PROJECT: Summerlin West V21 - Kimlo Corner Ave & Kettle Ridge Dr (Sky Vista Drive to Desert Foothills Boulevard) Update #4

CITY OF LAS VEGAS INTER-OFFICE MEMORANDUM				DATE: September 16, 2020
TO: **Land Development Services** Department of Building & Safety				FROM: Jennifer Shinn, P.E. Flood Control, Engr. Associate Department of Public Works
SUBJECT:	Drainage Study for: **Summerlin West V21 – Kindle Corner Ave & Kettle Ridge Dr (Sky Vista Drive to Desert Foothills Boulevard) – Update #4**			**COPIES TO:** VTN Nevada
Cross Streets:	SWQ Desert Foothill Blvd & Summerlin Pkwy			Howard Hughes Company, LLC
File Number:	F:\Depot\DSMemos\DS5111G.doc			Bart Anderson, P.E., DevCo
Parcel Number:	137-26-101-001			
Zoning Action:				
FEMA Flood Zone	YES	NO X		
Proposed Storm Drain	YES X	NO

Update #4 to the Technical Drainage Study for

Kindle Corner Ave & Kettle Ridge Drive (Sky Vista to Desert Foothills)

SHEET
GR1
11 OF 37 SHEETS

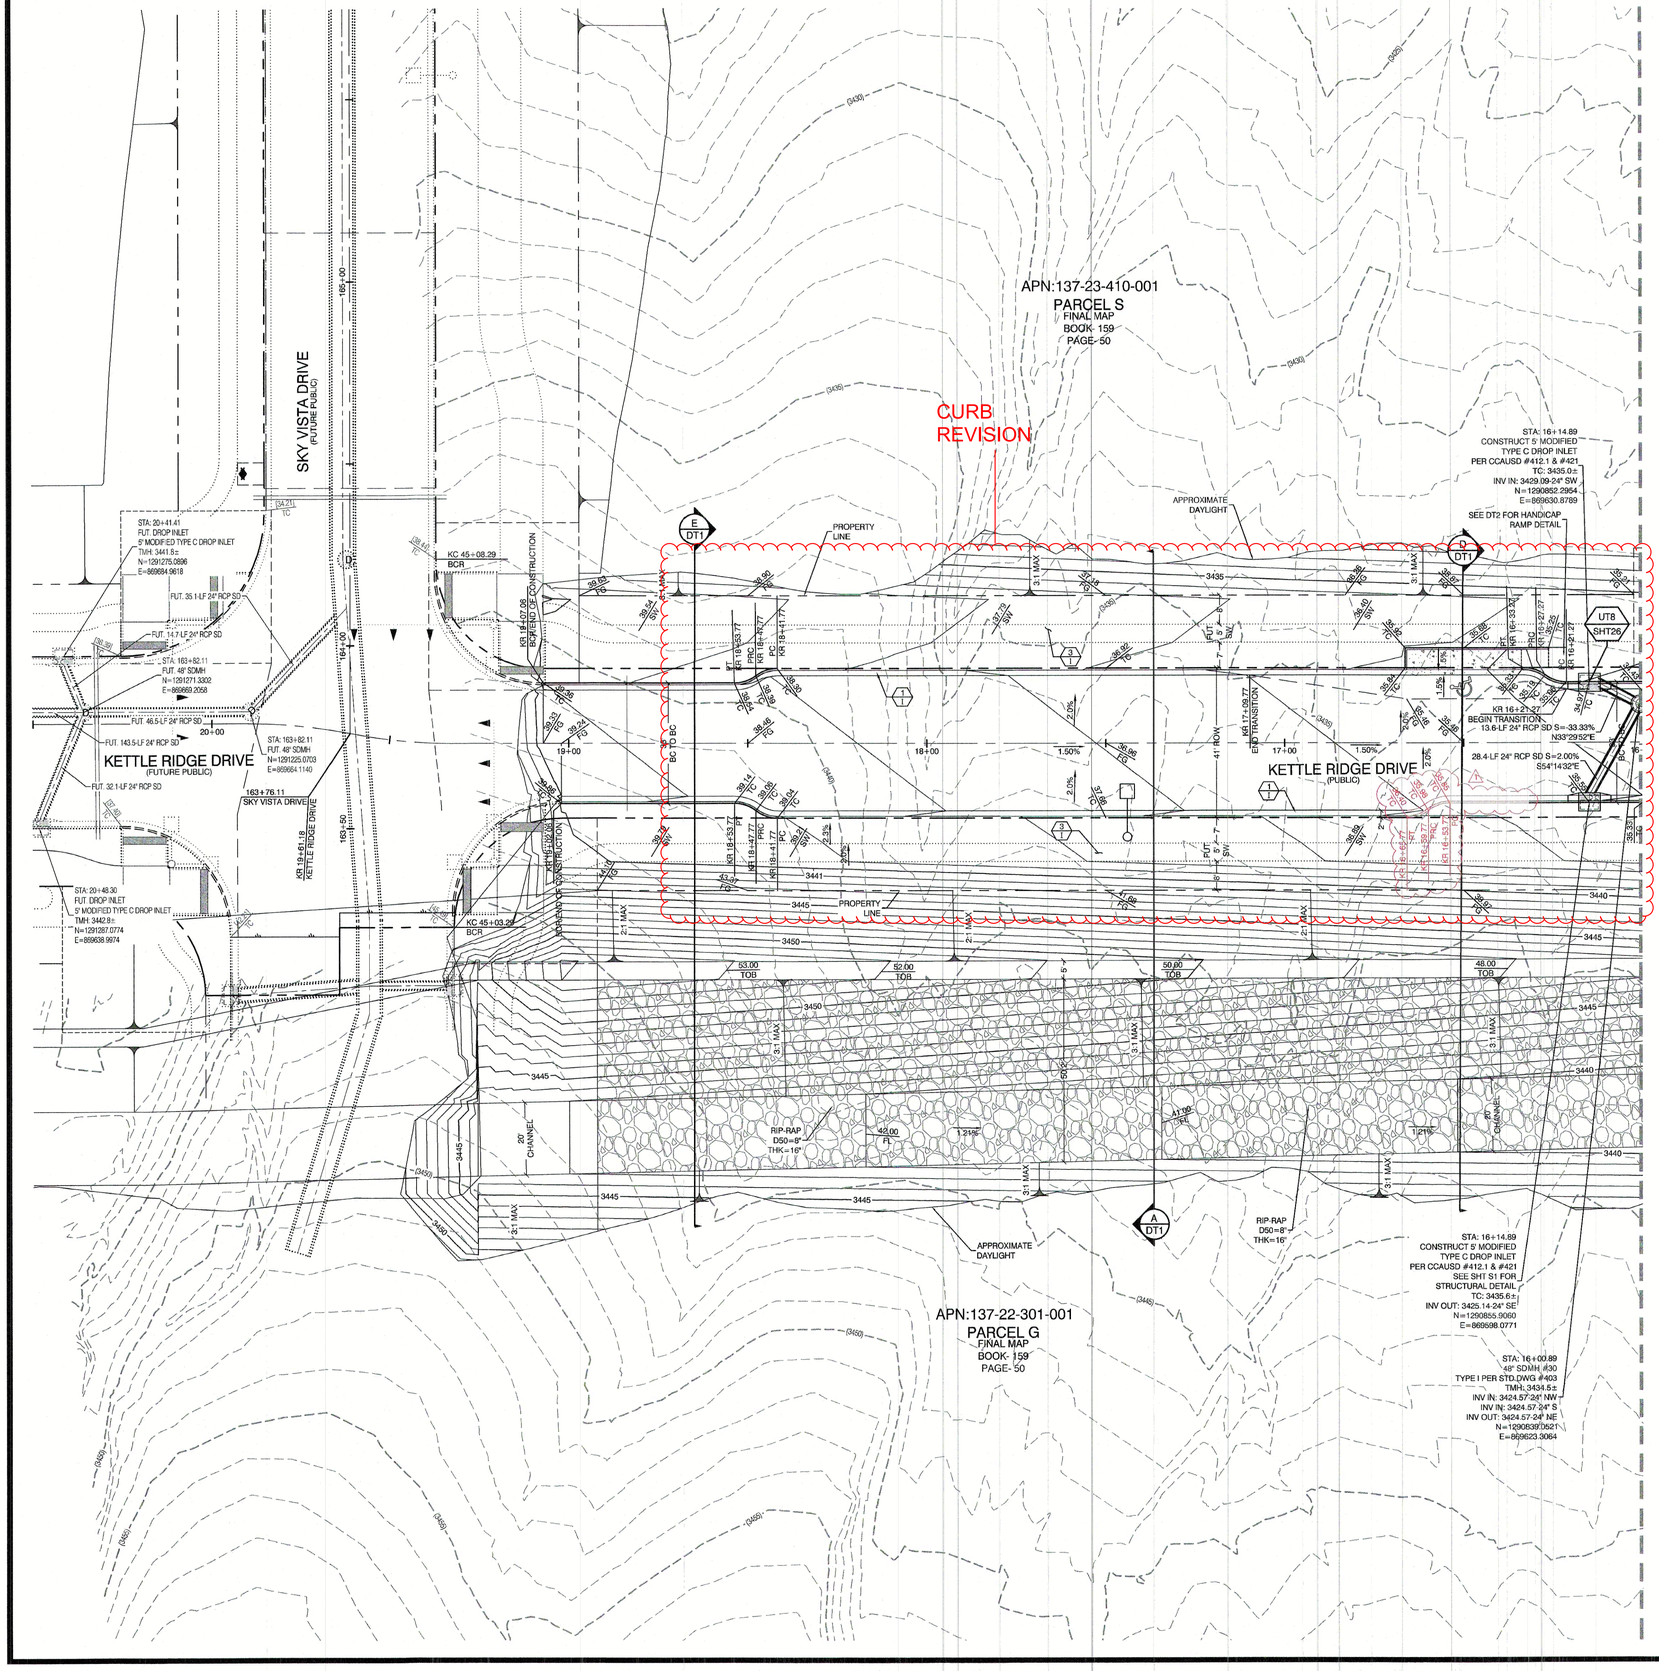
This update letter is being submitted to address revisions to the improvement plans since the approval of Update #3 of the subject drainage study. The plans have been revised to adjust the street curb, gutter, & edge of pavement, and remove parking stalls between Station 16+66 and 18+77 (refer to Sheet GR1). Flow will still be conveyed southerly towards the drop inlets near Station 16+15 as it did in the approved study, and flows will not be obstructed. In addition, flow magnitudes are not expected to increase. Therefore, calculated depths and velocities within the street will not be impacted and revised street hydraulic calculations are not required.

The improvement plan revisions submitted with this drainage study update will not alter drainage patterns and will not adversely impact upstream or downstream facilities or properties. Sheet GR1 of the approved plans has been clouded to indicate the location of the revision for your reference and included with this letter.
